## ADDITIONAL COMMENT RESPONSES AND REVISED ADDITIONAL SITE INVESTIGATION WORK PLAN

Re: Former Bayside Natural Cleaners  
8828 North Port Washington Road, Bayside, WI  
FID# 341140250, BRRTS# 02-41-548572

KPRG Project No. 18806.3

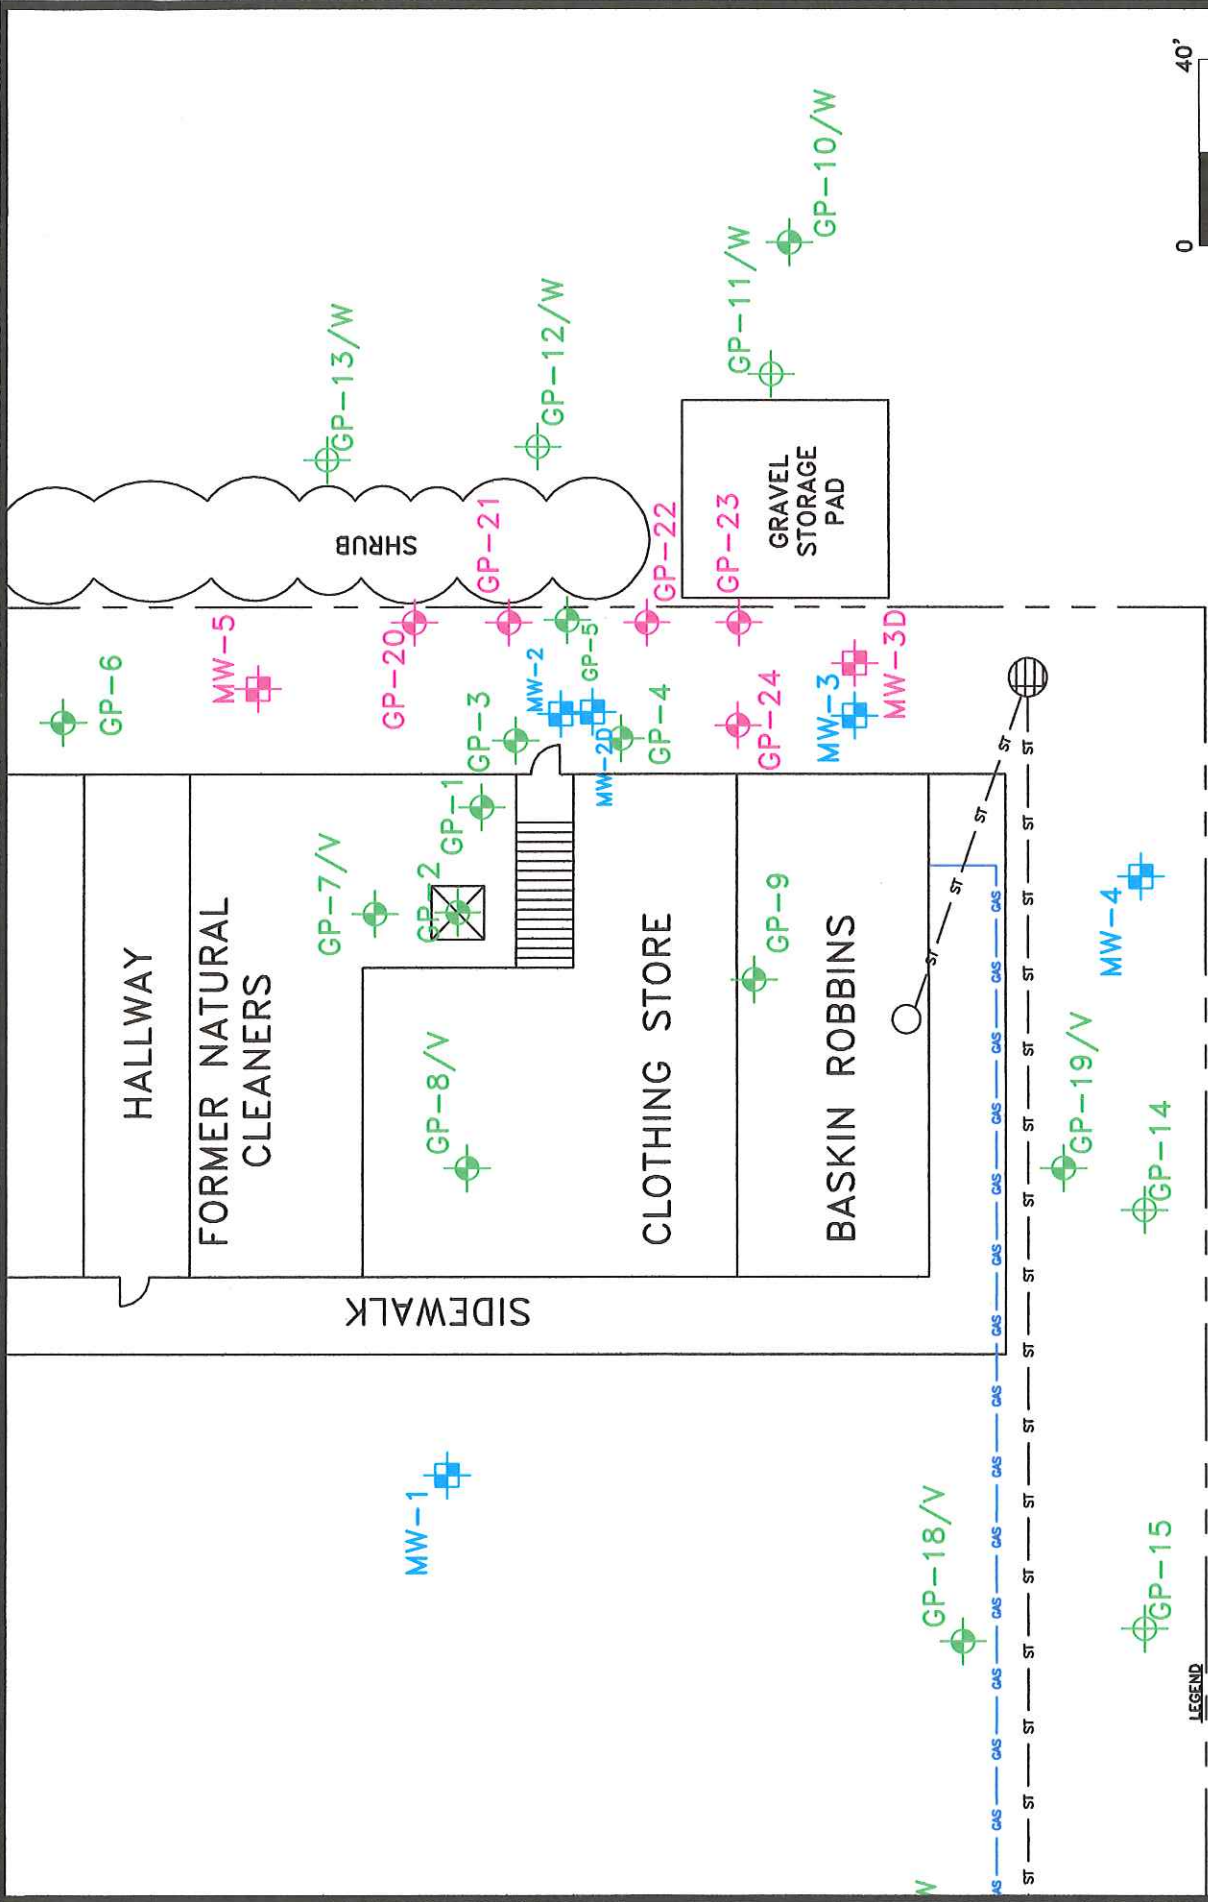
- Comment 1 – This comment requests additional soil borings to the north and south of location GP-5, along the east property line. These were part of the initial request addressed in the KPRG response dated May 31, 2016. In addition, soil borings to the

north towards location GP-6 and to the south towards well MW-3 are now also being requested.

- Comment 4 – This comment states that additional monitoring wells are required to the north of MW-2 and east on the adjacent property.

- Comment 5 – This comment requires an additional piezometer to be installed downgradient of the source area.

Response – The additional requested borings are included in the revised work plan and cost estimate provided in Attachment 1. This will yield a total of six additional soil sampling locations with two soil samples collected per location. The samples will be analyzed for chlorinated volatile organic compounds (CVOCs).

Response – An additional well (MW-5) will be installed to the north of MW-2 as noted in the revised work plan and cost estimate provided in Attachment 1. There are currently four monitoring wells on the adjacent property to the east. Multiple rounds of sampling from these wells have not detected impacts. Additional wells on this property are not warranted and are not included in the attached work plan.

Response – The revised work plan and cost estimate in Attachment 1 includes an additional piezometer to be clustered next to downgradient well MW-3.

KPRG will install six additional soil borings at locations noted on Figure 1 (locations GP-20 through GP-24 and MW-5). The soil borings will extend to at least 12 feet below ground surface (bgs). The soil borings will be advanced using the Geoprobe sampling technique. Continuous soil core samples will be collected. Each core will be field screened with a photoionization detector (PID) for total organic vapors. The core will also be visually inspected and logged using the Unified Soil Classification System (USCS).

KPRG will install two additional wells using hollow stem auger drilling. The well locations are shown on Figure 1. Well MW-5 will be a water table monitoring well installed to the north of existing well MW-2. The depth of this well is anticipated to be approximately 25 feet. A deeper piezometer (MW-3D) will also be installed adjacent to existing well MW-3. The depth of the piezometer is anticipated to be approximately 45 to 50 feet. Both wells will be constructed using schedule 40 PVC. The water table well will include a 10-foot screen and the piezometer will include a 5-foot screen. Surface completions will be flush mounts. All well construction will be performed in accordance with NR 141 requirements. Digger's Hotline will be contact to mark public utilities prior to drilling. In addition, a private locate firm will be contracted to check for additional private utilities within the proposed drilling locations.
